**TECHNICAL EVALUATION REPORT**

**EQUIPMENT ENVIRONMENTAL QUALIFICATION**

**POWER AUTHORITY OF THE STATE OF NEW YORK  
INDIAN POINT UNIT NO. 3**

**NRC DOCKET NO. 50-286**

Figure A-2. LOCA Condition Temperature Vs. Time Profile Within Containment [1]

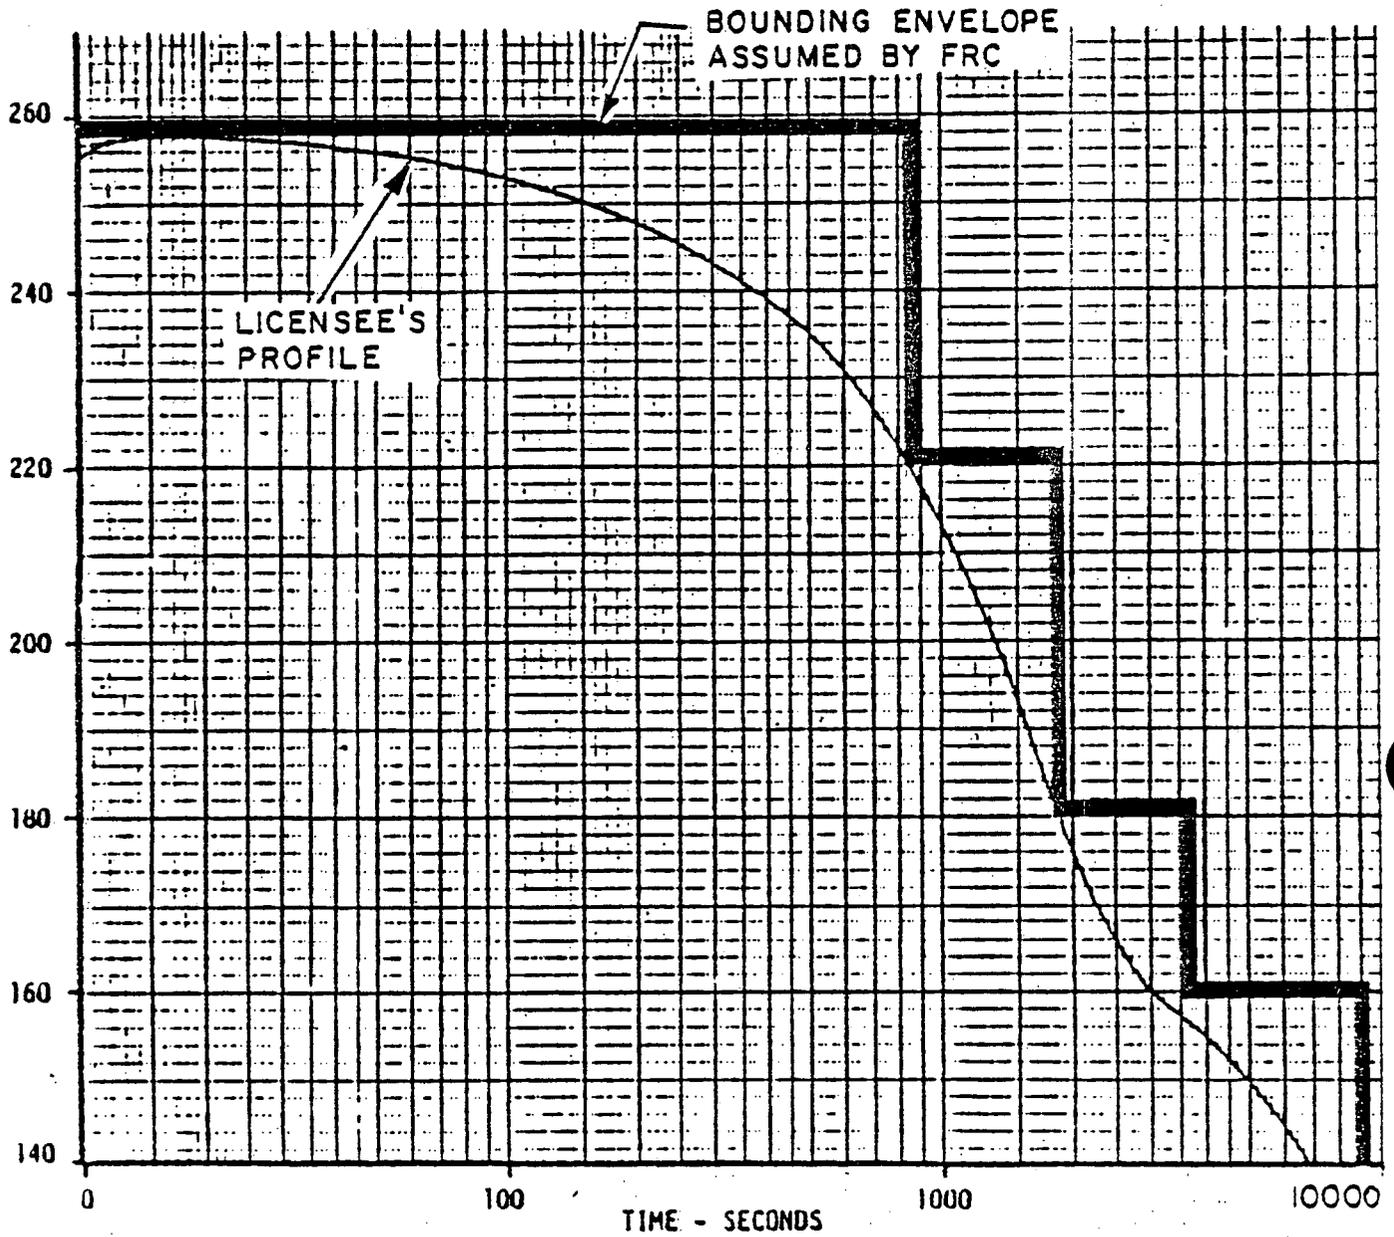
The adequacy of a plant-specific profile depends on the assumptions and design considerations at the time the profiles were developed. The DOR Guidelines and NUREG-0588 provide guidance and considerations required to determine if the calculated plant-specific temperature/pressure profiles encompass the LOCA and HELB accidents inside containment.
